## **CABINET MEMBER FOR HIGHWAY MANAGEMENT – 23 JUNE 2022**

### **COMBE: PROPOSED 20MPH SPEED LIMIT**

Report by Corporate Director, Environment and Place

Drawing title  
**Proposed  
20 mph speed limit**

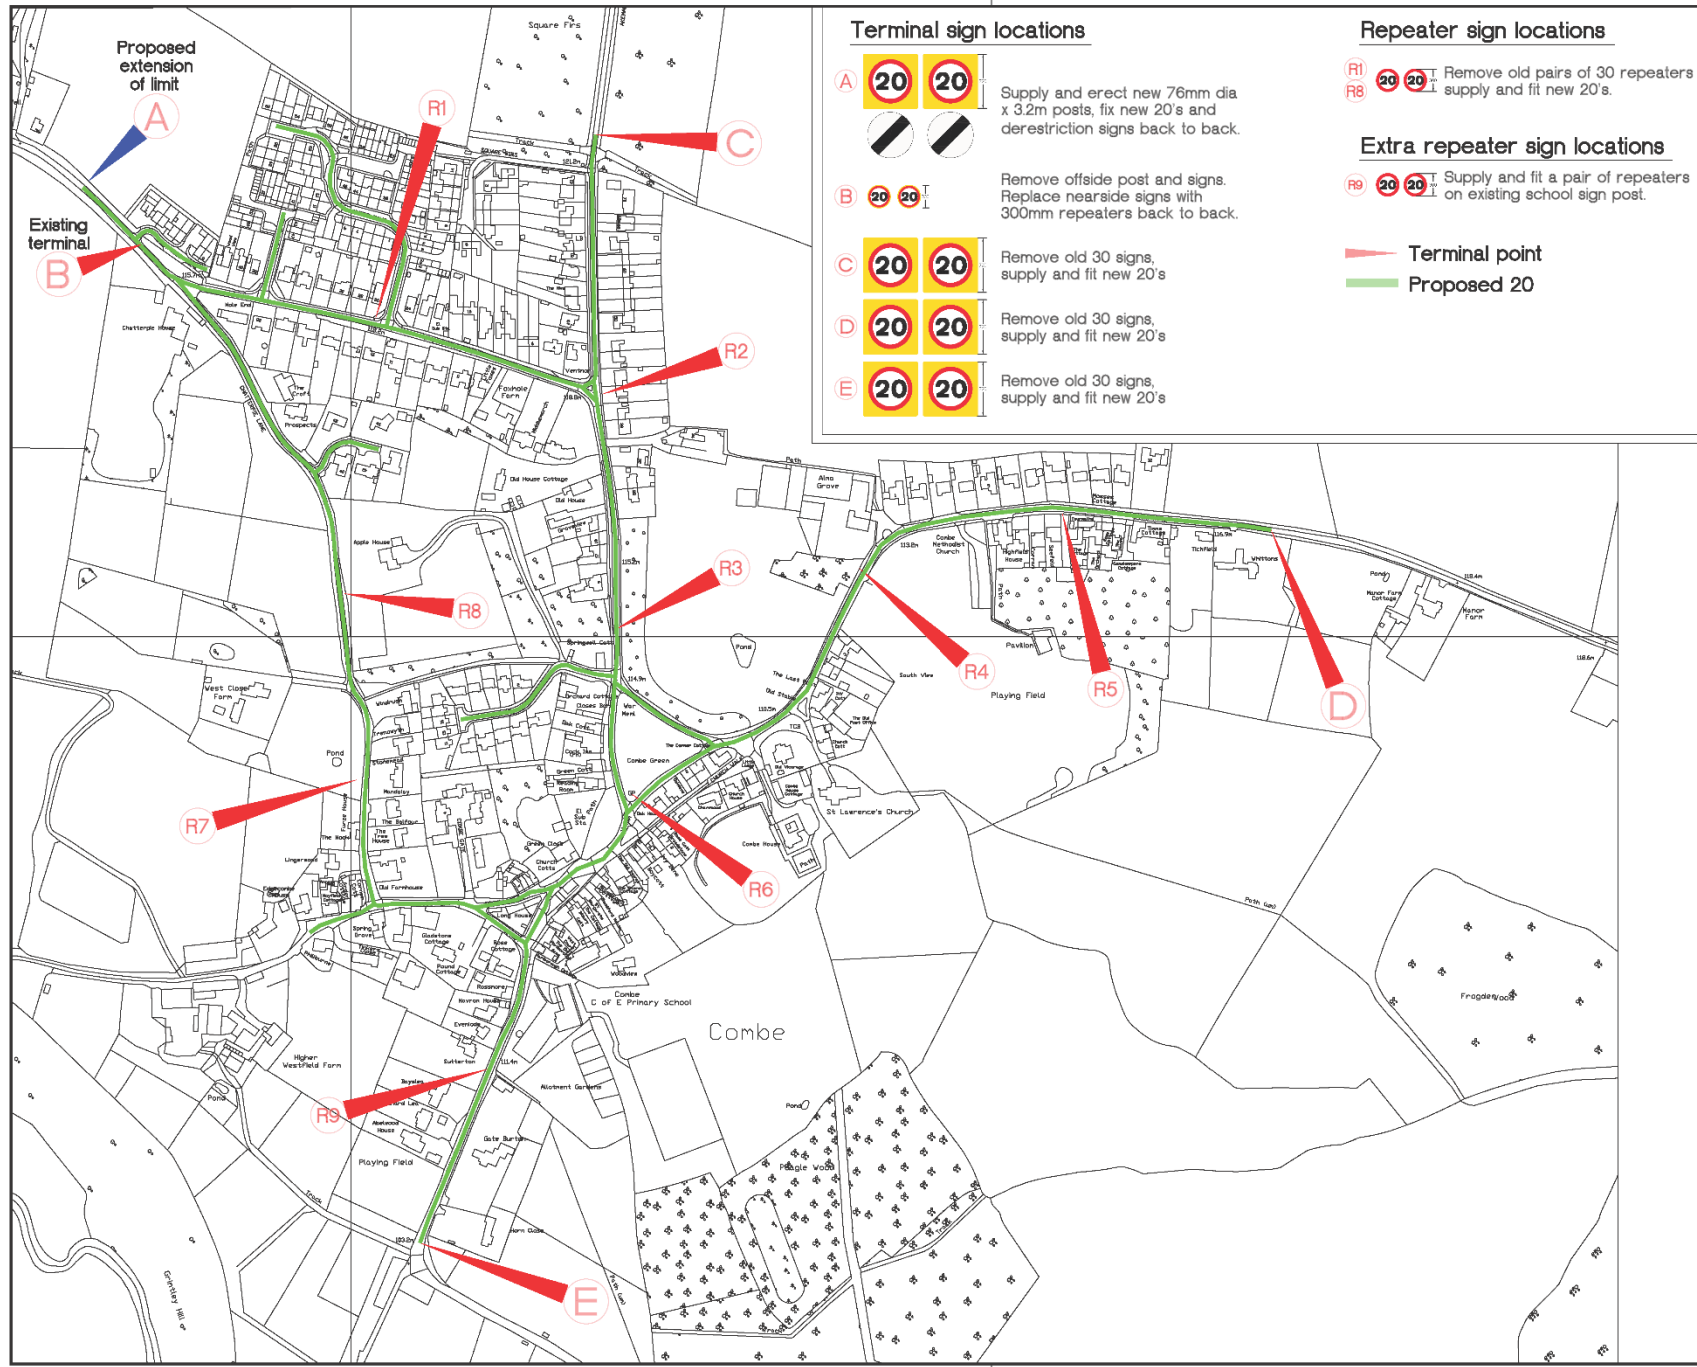
9. Thames Valley Police stated that speed data had been received for the proposed 20mph limit taken in 2017 which does not support lowering the limit on some of the roads namely, Robin Hill & Akerman Street. Other engineering measures should be considered for these locations.
10. The county council is changing its approach and acceptance of 20mph restrictions which will enable a much greater coverage across Oxfordshire. The proposal is aimed to make streets safer, encourage residents to walk or cycle & reduce noise and pollution. With specific reference to Robin Hill & Akerman Street, these locations within the proposed 20 limits comply broadly with OCC qualifying criteria as set out in the counties current 20mph speed limit policy.

RESPONDENT	COMMENTS
(1) Traffic Management Officer, (Thames Valley Police)	<p><b>Object</b> – Thames Valley Police are not opposed to lowering speed limits providing they are appropriate to the road environment and likely to have casualty reduction benefits .All aspects of the proposed speed limit are taken into account i.e. collision history ,speed of existing traffic, road environment, enforcement, road character and driver perception etc.</p> <p>The current speed of traffic is a reliable indicator of how acceptable a new speed limit would be. If the mean speed is over the proposed limit it is unlikely to be effective without other measures such as engineering or continual enforcement.</p> <p>There is a proven link between road environment/character and drivers speed .Drivers must respect the need for a speed limit. If it is not accepted as realistic it will quickly be abused and be the source of constant demands for police action.</p> <p>The police stance still reflects that 20mph limits and zones should still be self-enforcing. The policy of Thames Valley Police is to use sound practical and realistic criteria (Circular Roads 1/2013) when responding to Highway Authorities in an effort to promote consistency and to reduce the burden of constant and unnecessary enforcement. The advice shown in Circular Roads 1/2013 states Speed Limit should not be used to attempt to solve the problem of isolated hazards for example a single junction or reduced forward visibility.</p> <p>Speed data has been received for the proposed 20mph limit taken in 2017 which does not support such a lowering on some roads namely: Robin Hill &amp; Akerman Street.</p> <p>Unless other engineering is being considered for these locations the Police object.</p>
